## **POLLUTANT REDUCTION PLAN ADDENDUM**

LOWER NAZARETH TOWNSHIP

**Revised September 2024**

MS4 VEGETATED SWALE  
 & RIPARIAN FOREST BUFFER

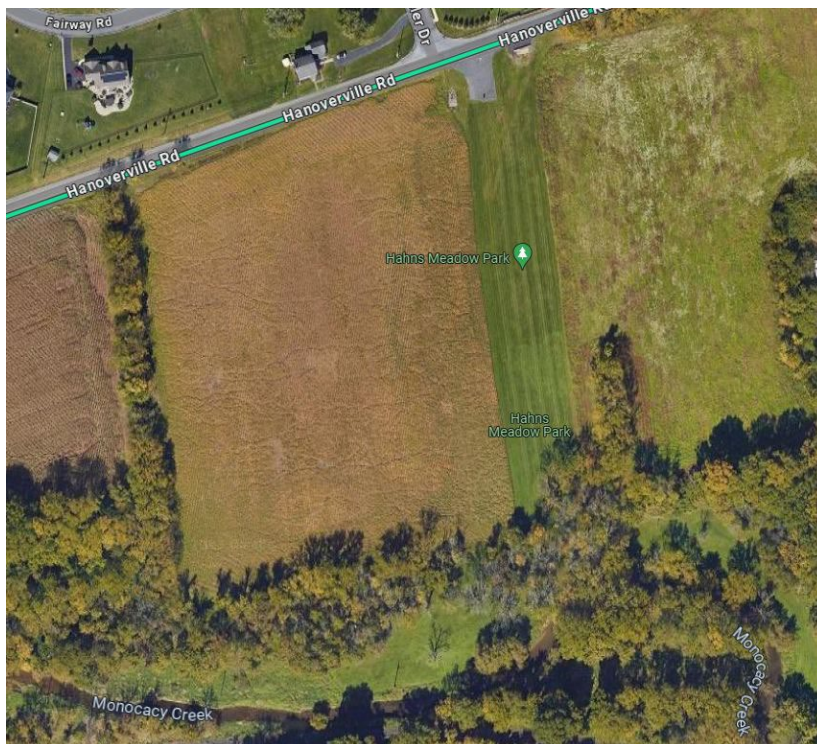
This PRP amendment proposes the planting of diverse native vegetation within the swale channel that is located on Township-owned land. The swale is in the watershed area for Outfall #004. The proposed vegetated swale is to be a non-invasive (no land disturbance) modification to the existing grass-lined open channel. The proposed enhancements will restore native meadow-type vegetation to provide an opportunity for substantial sediment removal. The existing swale will be hand planted with no heavy construction equipment utilized within the channel.

**Hahn’s Meadow Riparian Forest Buffer and Vegetated Swale** - is located just south of the intersection of Schindler Drive and Hanoverville Road. The existing swale, designated as a stream on the DEP eMap, is proposed to be enhanced via both stabilizing with hand-planted vegetation and installing a riparian forest buffer along both sides, totaling approximately 1,320 linear feet.
